AGENDA
DESIGN COMMISSION
Community Room, 3rd Floor
Arlington Heights Village Hall, 33 S. Arlington Heights Rd.
Arlington Heights, IL 60005
October 28, 2025
6:30 PM

Item: 1500 E. Euclid Ave. - SF/Teardown - DC25-065 (continued from 10/14/25)

STAFF DESIGN COMMISSION REPORT RE-REVIEW

Project Name: 1500 E. Euclid Avenue
Project Address: 1500 E. Euclid Avenue
Prepared By: Steve Hautzinger

SHEET
A109

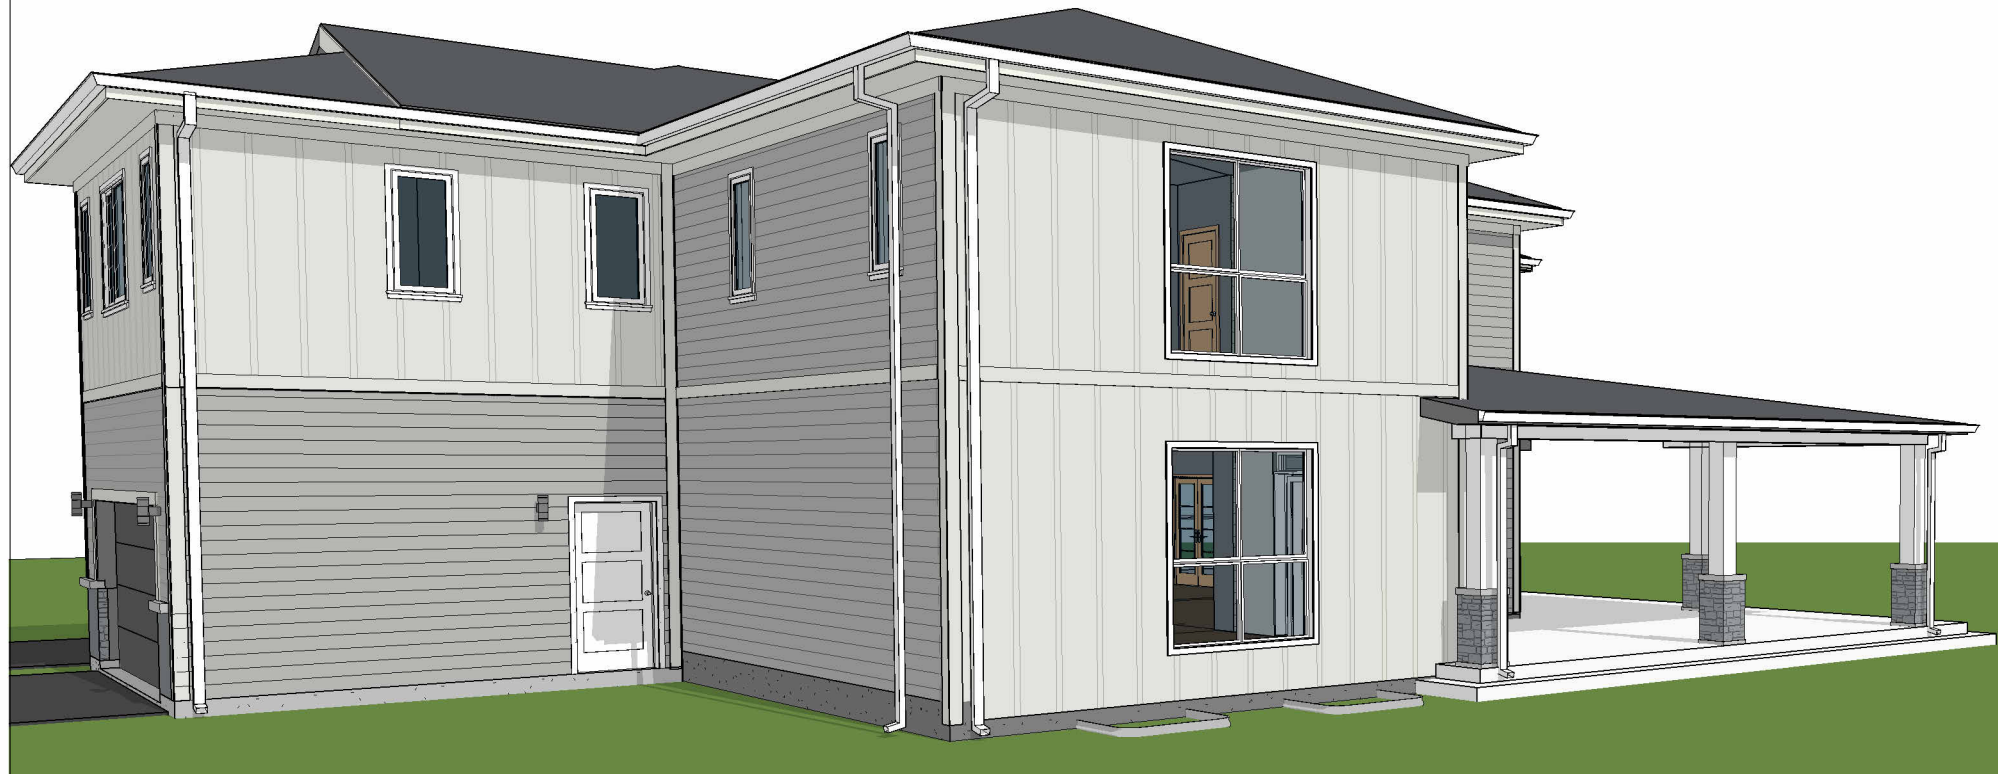
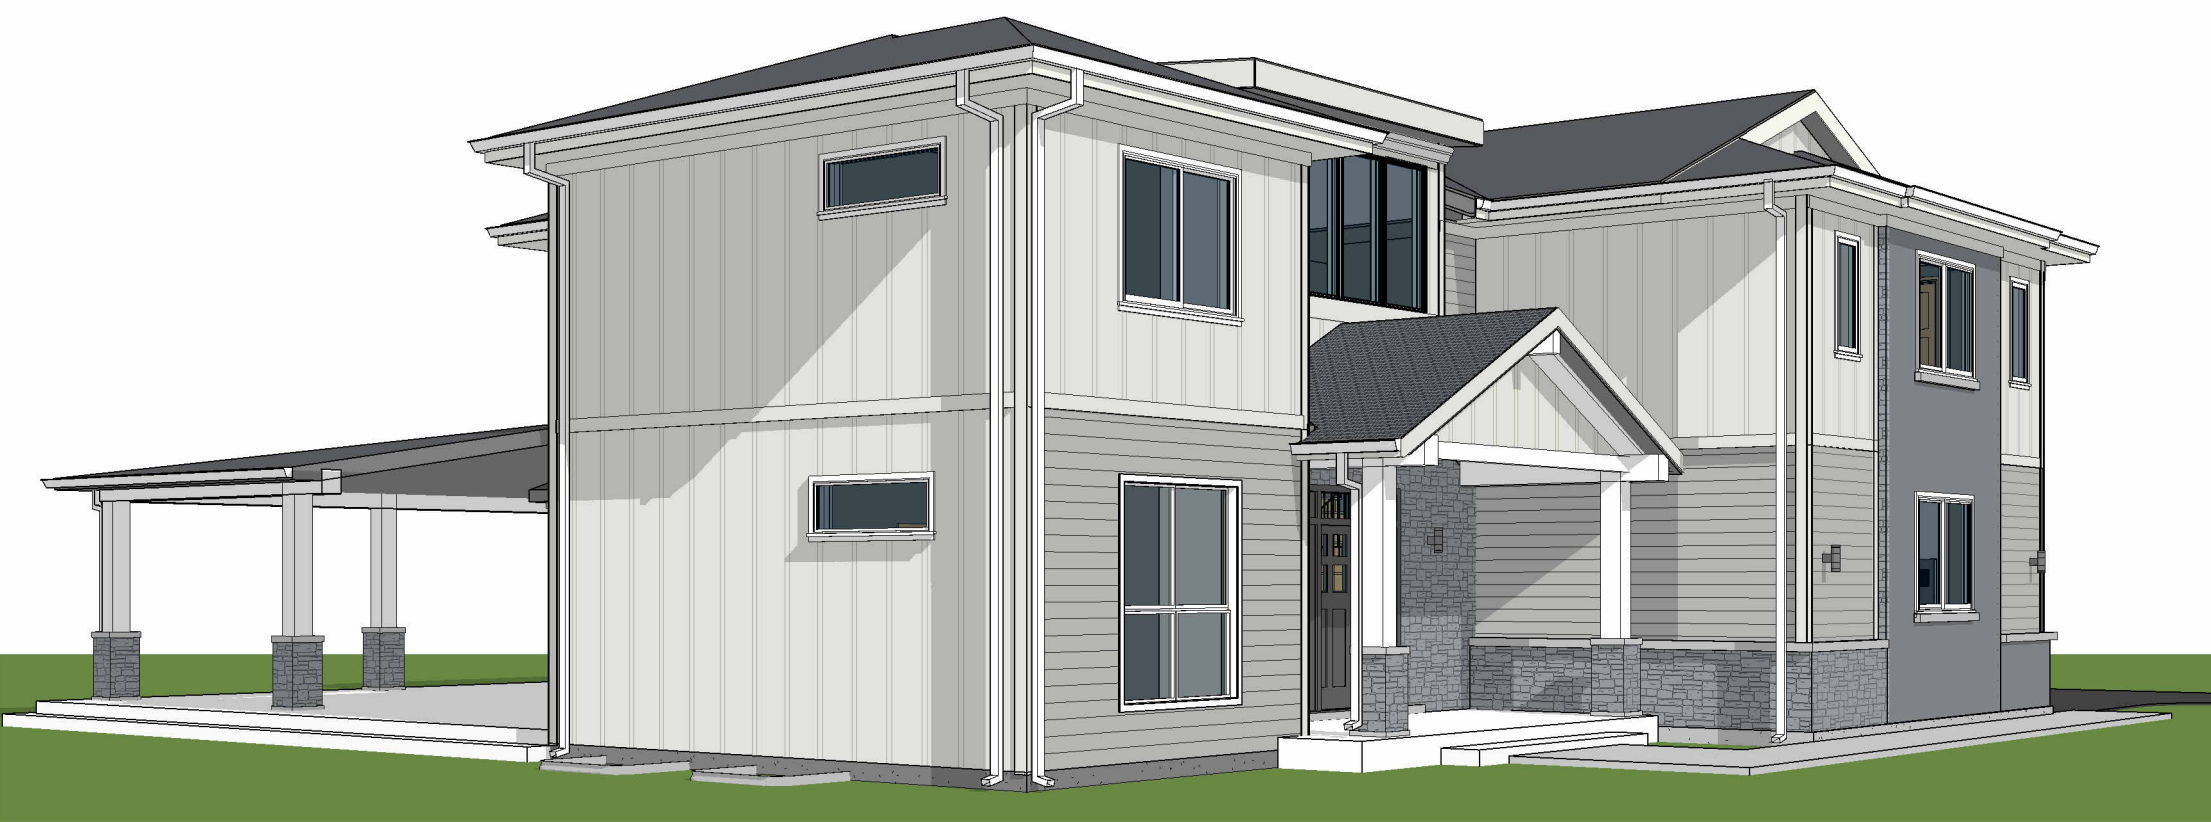
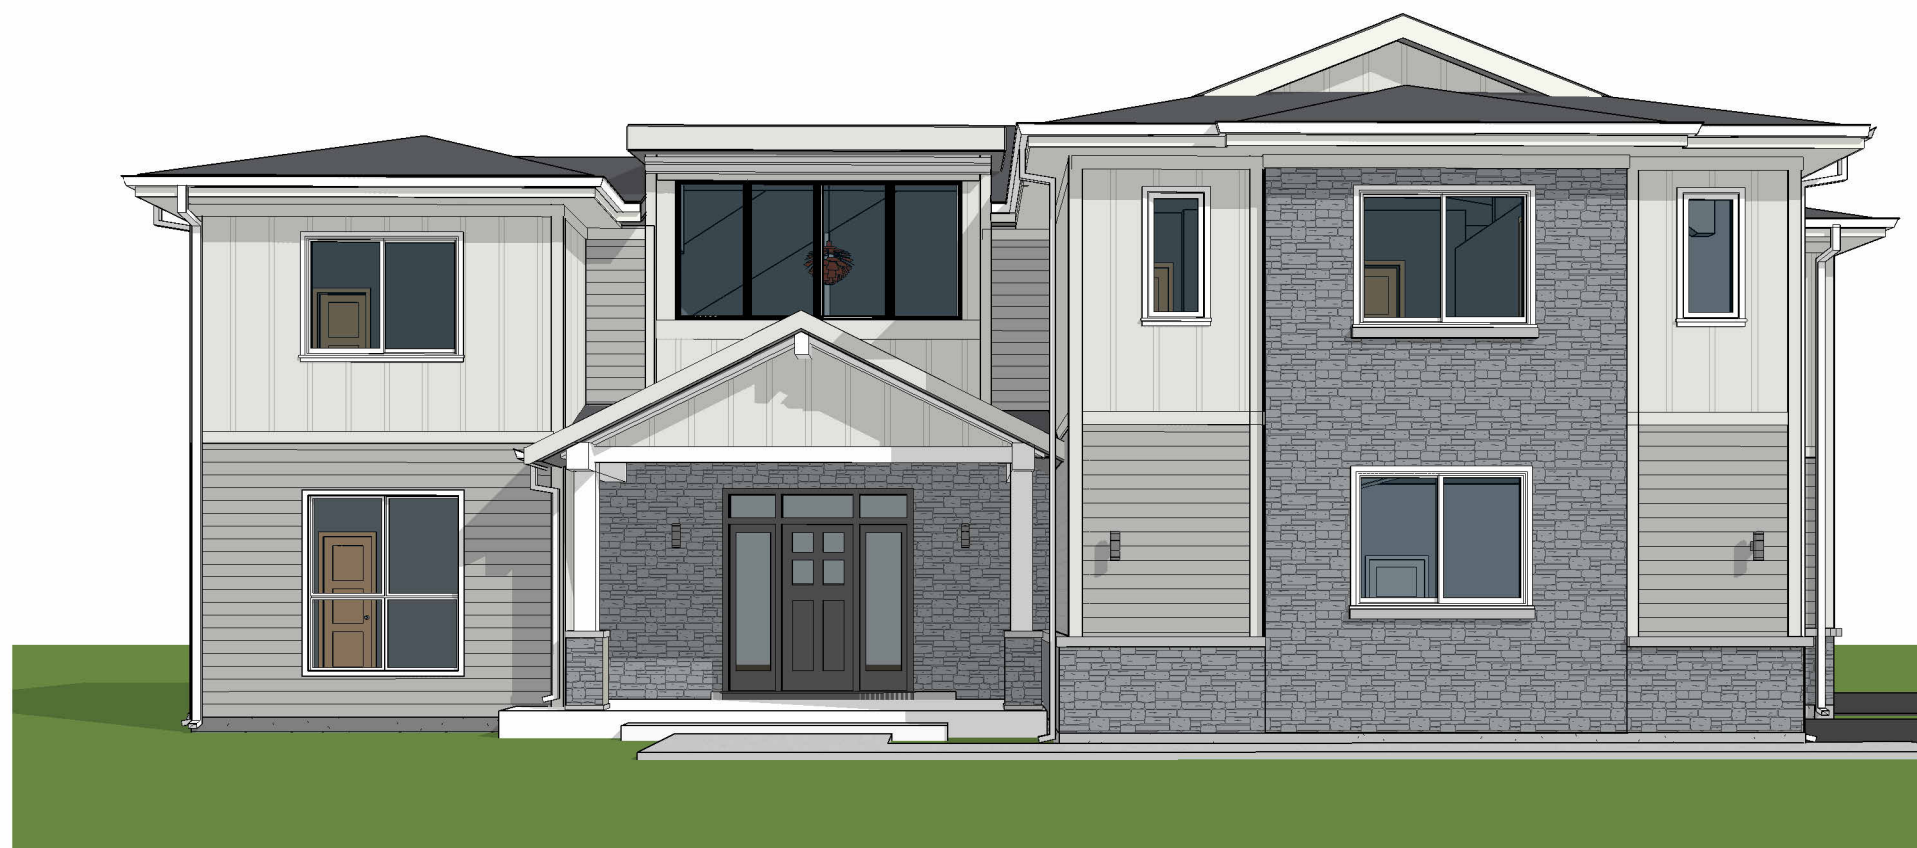
The petitioner has provided revised plans in response to the Design Commission's comments. A summary of the changes is as follows:

- The front door has been changed to a more traditional front door design with sidelights and transom.
- The front and rear porch columns have been changed to a more substantial simple white box column design.
- The windows on all sides of the house have been revised with a more uniform style, sizing, and head height.
- Wall sconce light fixtures have been added to front garage elevation as well as at all exterior doors.
- The rear patio roof is improved with a separate roof/awning above the patio door.
- Numerous 3D renderings have been provided for review.

Staff feels that the petitioner did a good job addressing the majority of the Design Commission's concerns, resulting in a more cohesive design. The only item that still looks unresolved is the application of the horizontal gray siding and the vertical white siding which changes randomly from wall to wall and first floor to second floor. For a simpler appearance, it is recommended to make the entire first floor on all sides of the house gray horizontal siding, and make the entire second floor on all sides of the house white vertical siding. One other minor detail is a recommendation to center the wall sconce light fixtures on the south (front) wall of the garage below the second floor windows above.

1. A recommendation to make the entire first floor on all sides of the house gray horizontal siding, and make the entire second floor on all sides of the house white vertical siding.

2. A recommendation to center the wall sconce light fixtures on the south (front) wall of the garage below the second floor windows above.
3. This review deals with architectural design only and should not be construed to be an approval of, or to have any other impact on, any other zoning and/or land use issues or decisions that stem from zoning, building, signage or any other reviews. In addition to the normal technical review, permit drawings will be reviewed for consistency with the Design Commission and any other Commission or Board approval conditions. It is the architect/homeowner/builder's responsibility to comply with the Design Commission approval and ensure that building permit plans comply with all zoning code, building permit and signage requirements.
